Capstone Student Housing

Project Title: Capstone Student Housing - Zone 2 Area Building Permits City Drainage #: M15D026
DRB#: 1009090 EPC#: 11EPC-40091/40092/40093 Work Order#: _____
Legal Description: Parcel 1A block 3 of Lots 1A, 2B, in Block 3, Parcels 1A1, 1A2, 1B1 in Block 4, Parcels 2A, 2B, 2C, & 2D of Sunport CONT
City Address: _____

**Re: Revised Capstone Drainage Management Plan
Zone 2 Grading Plan
Engineer's Stamp Date 11-20-2013 (M-15/D026)**

From: Biazar, Shahab
Sent: Thursday, November 14, 2013 10:28 AM
To: Jeffrey Wooten (jwooten@tierrawestllc.com)
Cc: Sims, Timothy E.
Subject: Capstone Housing Grading Plan - ZONE 2 (M15/D26)
Attachments: M15D026_ZONE2_SHAHAB_MARKUPS.pdf

Shahab's
Markups

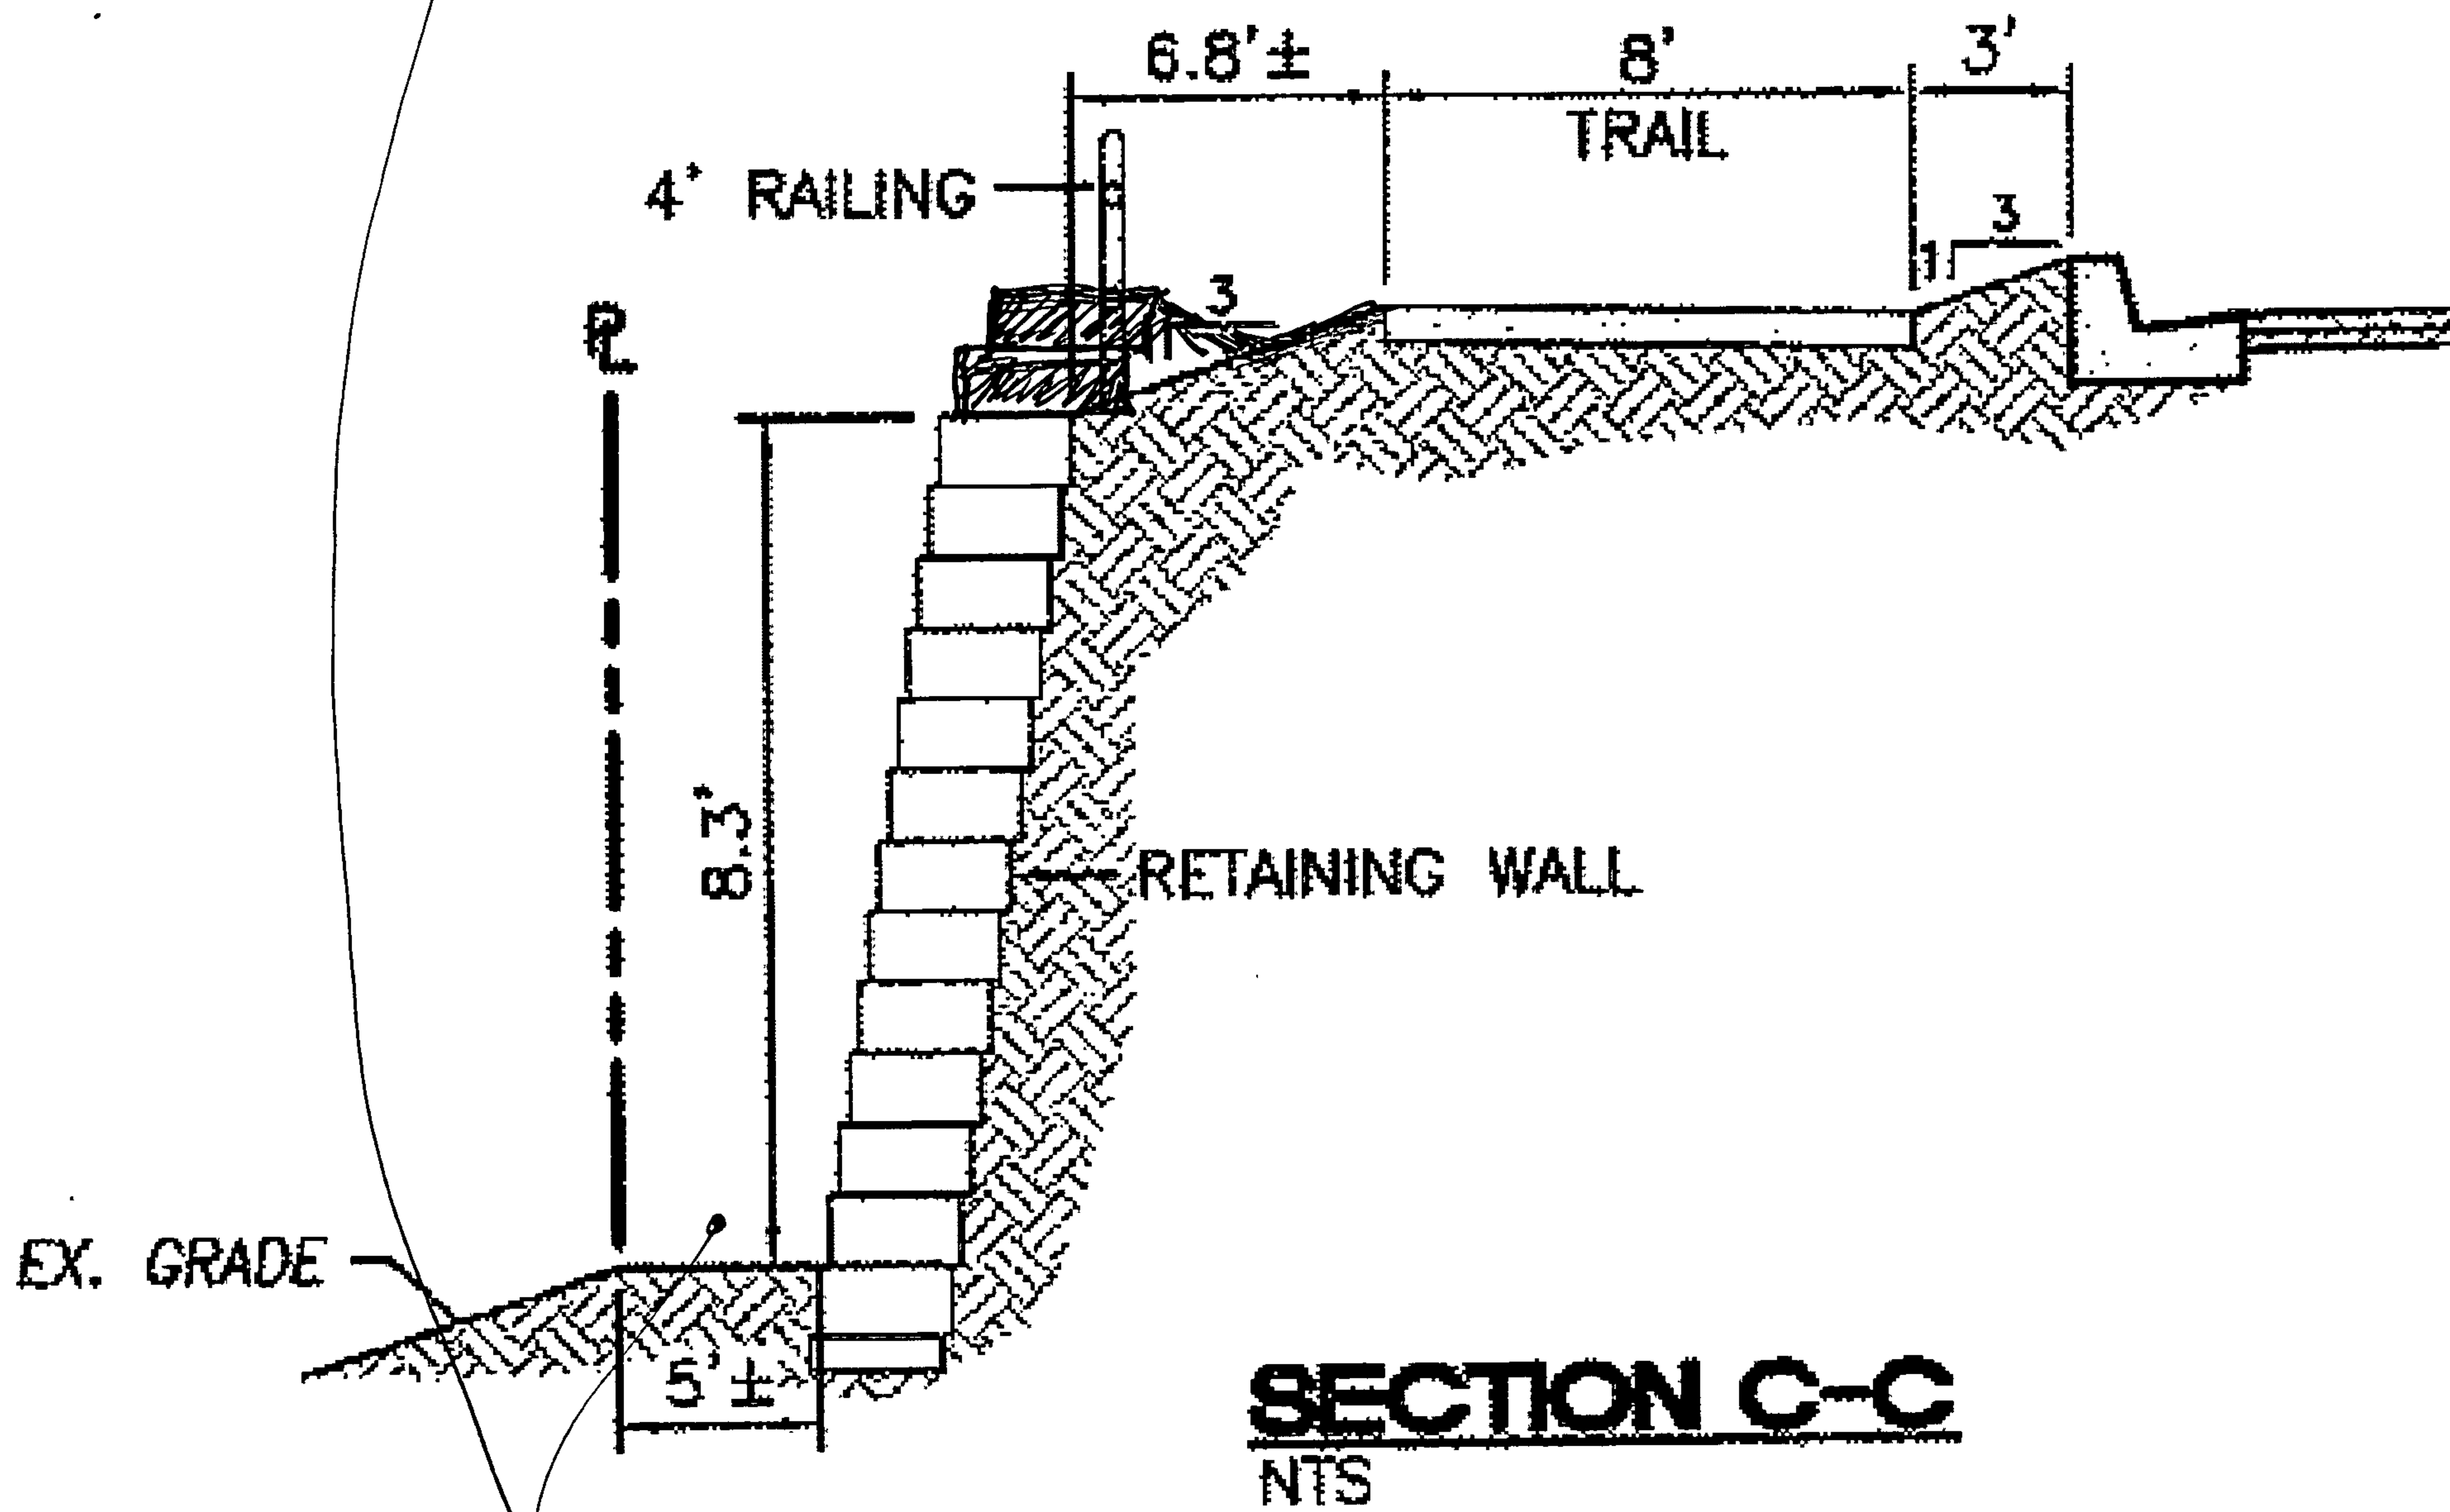
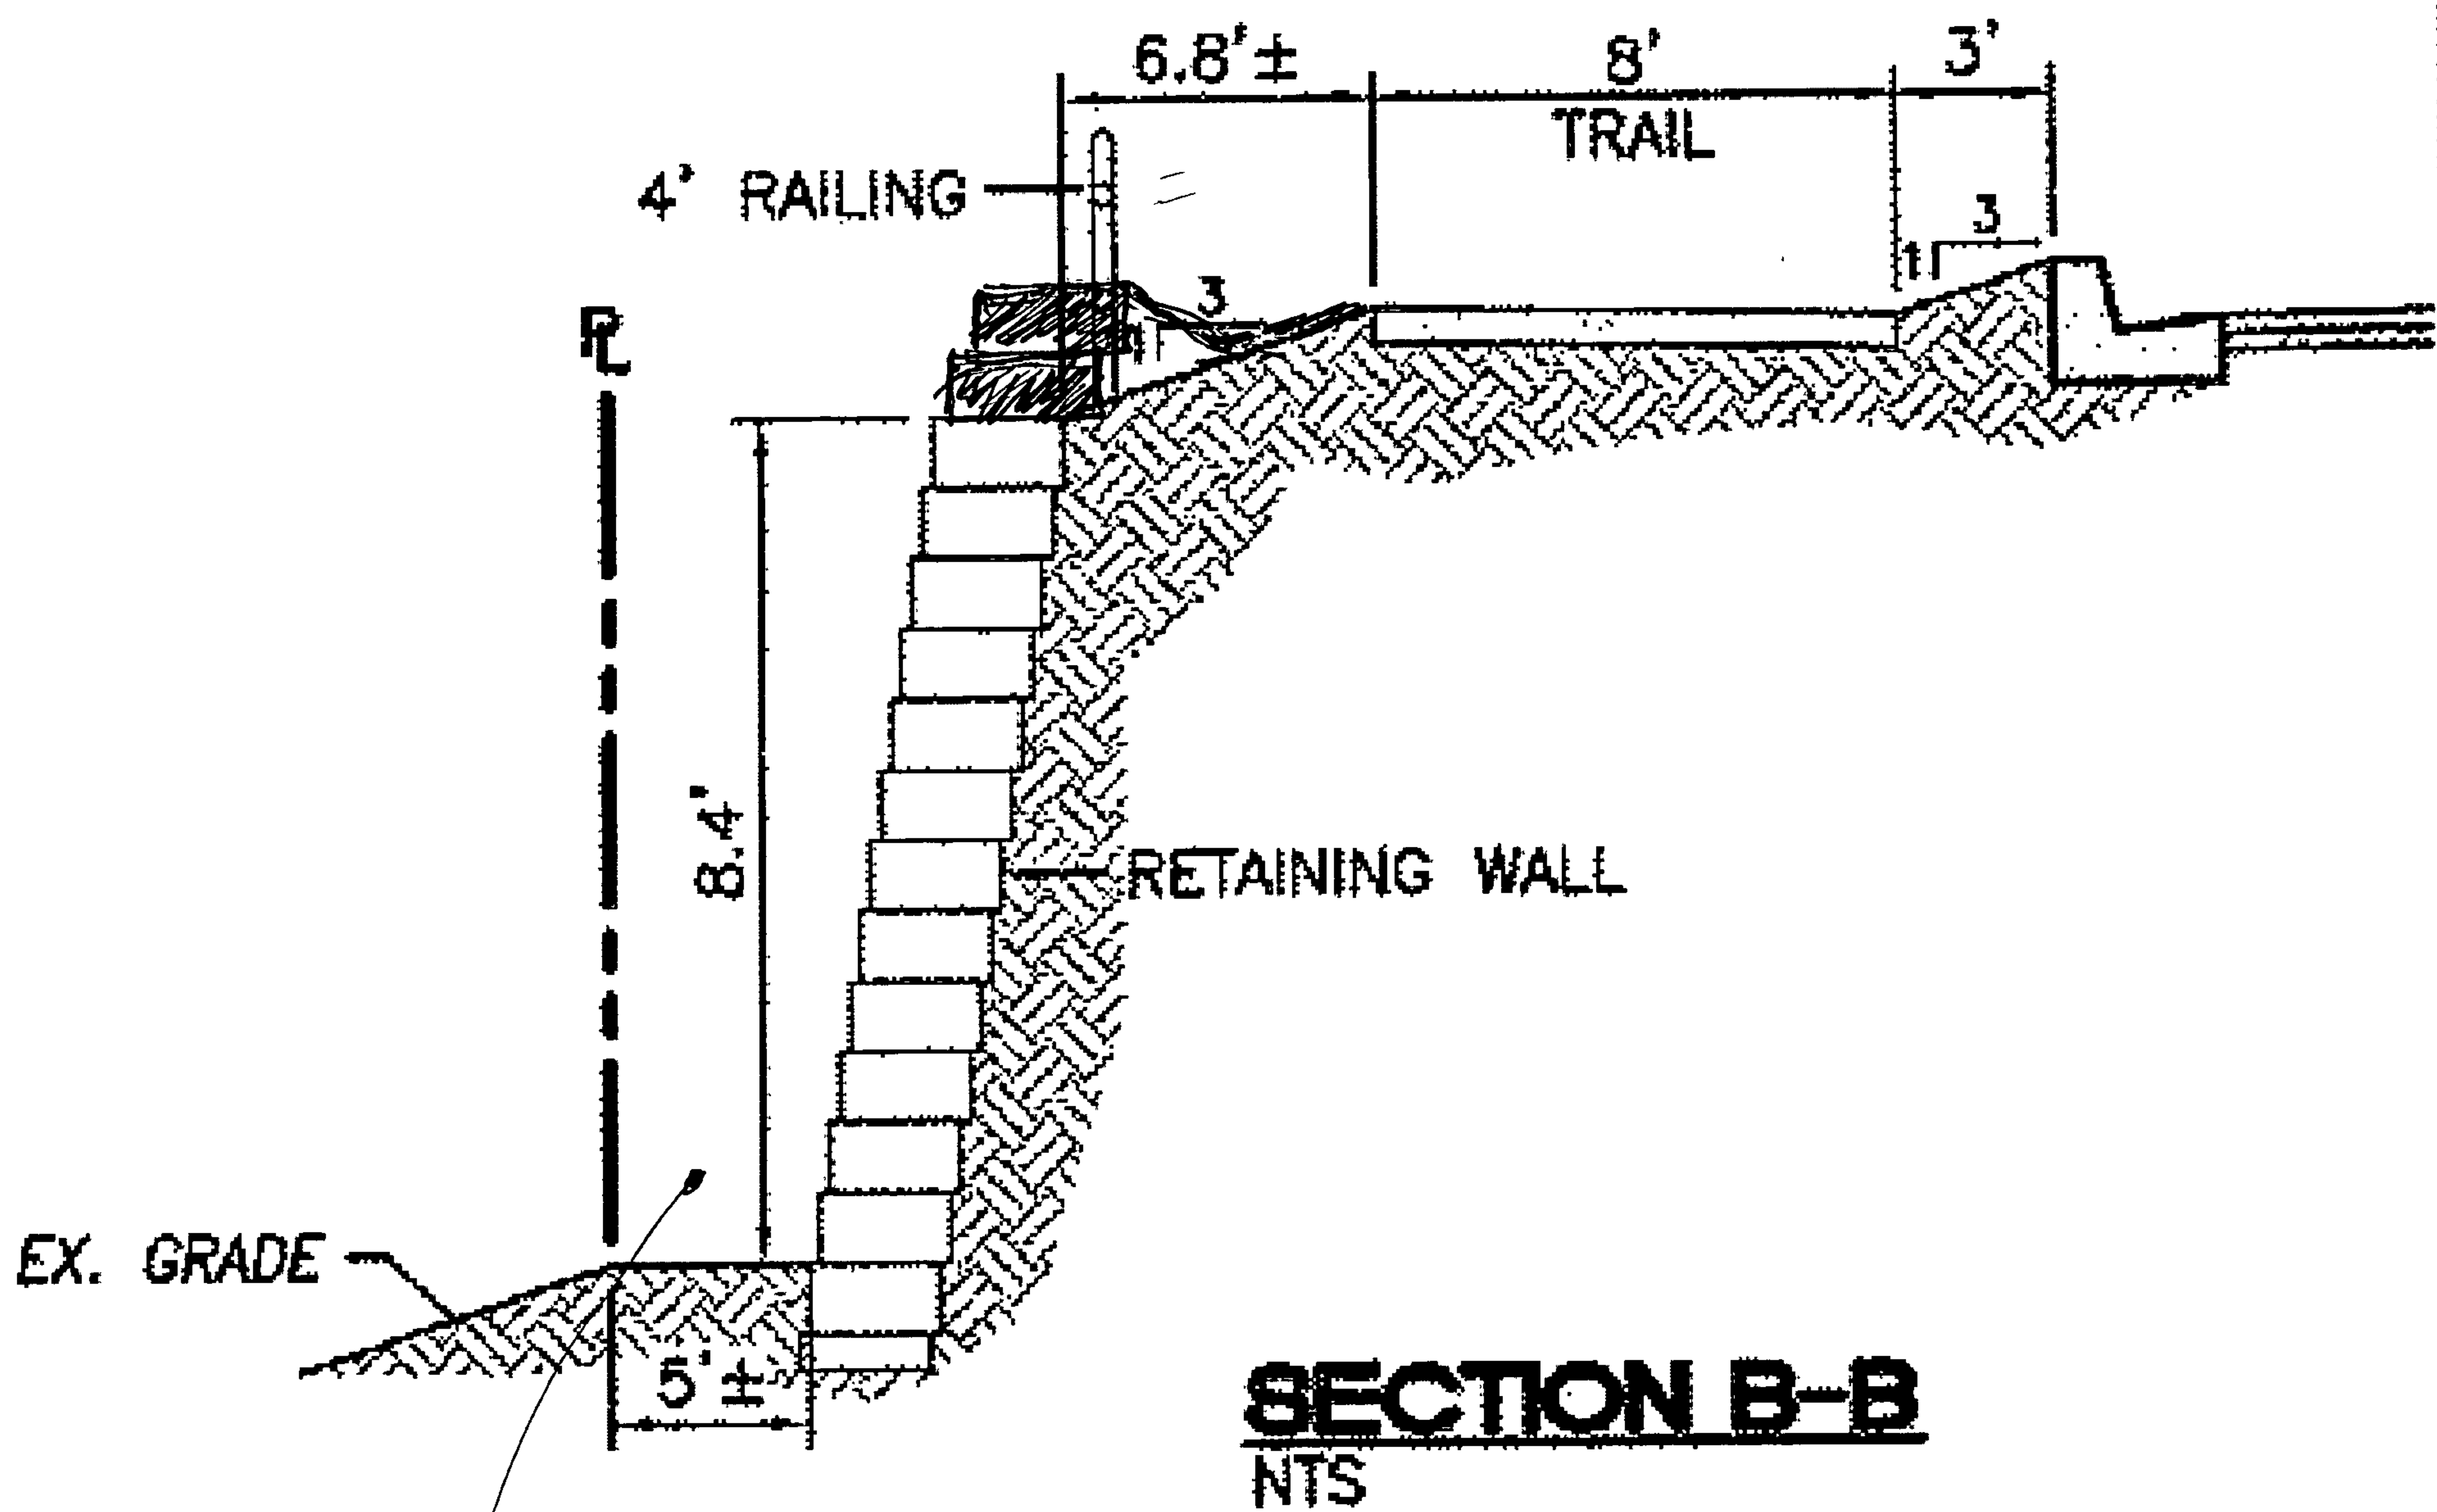
How is the wall being constructed where by the drop inlet? Will there be any conflict with tension mats? Are there any other conflicts with utilities?

Can the Wall
Be Moved to R
To give More Distance
to Slope

- We may have to remove the inlet as shown on the plan. The reason for having this previously was because of the cast in place wall and minimizing and drainage behind the wall. In the case of the Keystone wall, drainage should be ok to flow to the wall and over if necessary. There will not be any concentrated flows in this case and the area draining to the wall is only a 13' wide landscape area. The multi-use trail is constructed of crusher fines and is pervious.

- I am not aware of any conflicts with the tension mats except for the aforementioned drop inlet. Removing the inlet as suggested would solve this issue. Let me know your thoughts so I can adjust the plan and resubmit.

- I am not aware of any other conflicts with utilities except where the existing public sanitary sewer and storm drain lines will cross under the wall. These existing lines are very deep and will not be in direct conflict with the geo-grid.

*I talked w/ Jeff & he will come up w/
an alternative Plan Shahab 11/18/13*
